ERCOUPE SERVICE BULLETIN NO. 34

ELEVATOR CONTROL HORN INSPECTION

DATE: January 4, 2013 Revision None

SUBJECT: Visual inspection of the steel elevator control horn and its mating aluminum channel for evidence of corrosion.

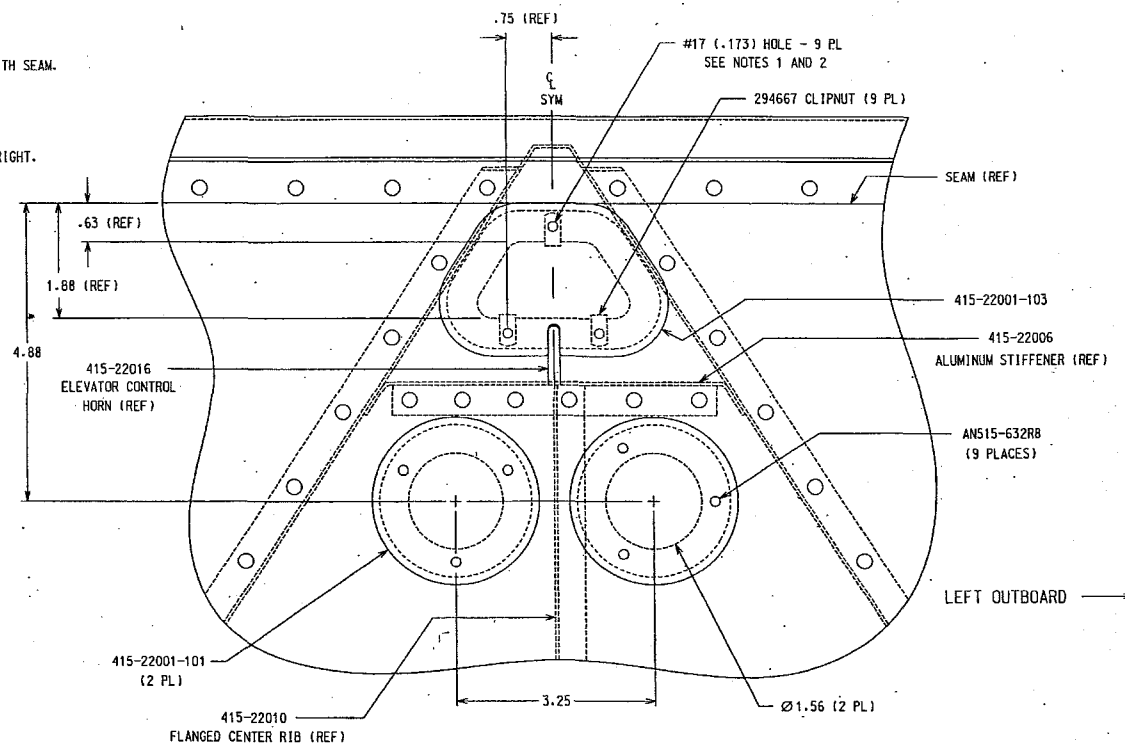
Univair has determined that two 1.56 diameter holes and one trapezoidal shaped hole located at the center of the bottom elevator skin will provide adequate inspection coverage of the attachment area of the steel elevator control horn. See Univair drawing 415-22013 INSP for layout dimensions of inspection holes.

The elevator should now be free to lift up and mark inspection access hole locations as detailed on drawing 415-22013 INSP.

4. Cut two 1.56 diameter holes in lower elevator skin aft of the aluminum stiffener per drawing 415-22013 INSP. Locate the inspection hole forward of the aluminum stiffener using template 415-22001-105, per drawing 415-22013 INSP. Locate and drill #17 holes as required.

1. LOCATE .173 HOLES AND FORWARD INSPECTION HOLE WITH 415-22001-105 TEMPLATE. ALIGN FORWARD EDGE OF TEMPLATE WITH SEAM.
2. ORIENT LEFT SIDE 415-22001-101 SUCH THAT .173 HOLES AND 294667 CLIPNUTS CLEAR CENTER RIB FLANGE. CLIPNUTS NOT SHOWN AT 415-22001-101 LOCATIONS.
3. VIEW IS OF LOWER ELEVATOR SKIN. LEFT OUTBOARD IS TO THE RIGHT.
